SI B13 04 09
Fuel Systems

May 2013
Technical Service

This Service Information bulletin supersedes SI B13 04 09 **dated March 2013.**

N54 Engine: Diagnosis of Cold Start Rough Running with Misfire Faults

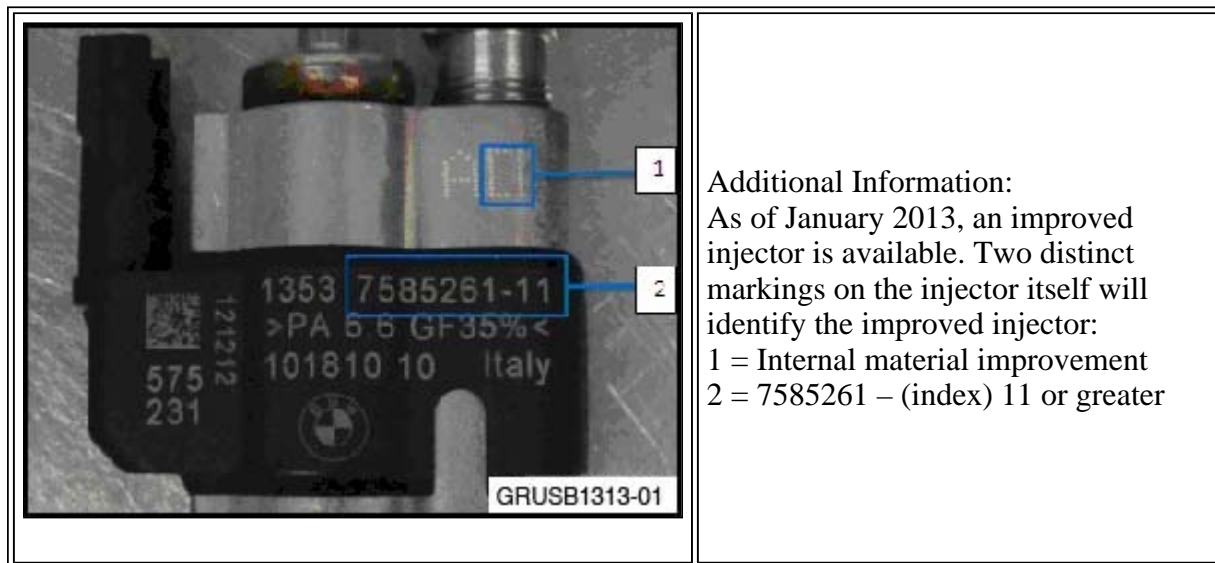
See the photo below to properly identify the index number.

IMPORTANT: Injectors with index 11 and higher have a different calibration and construction than injectors with index 10 and lower.

Due to this difference, the injectors with index 11 and higher and injectors with index 10 and lower cannot be mixed on the same engine bank (i.e., cylinders 1-3 or 4-6).
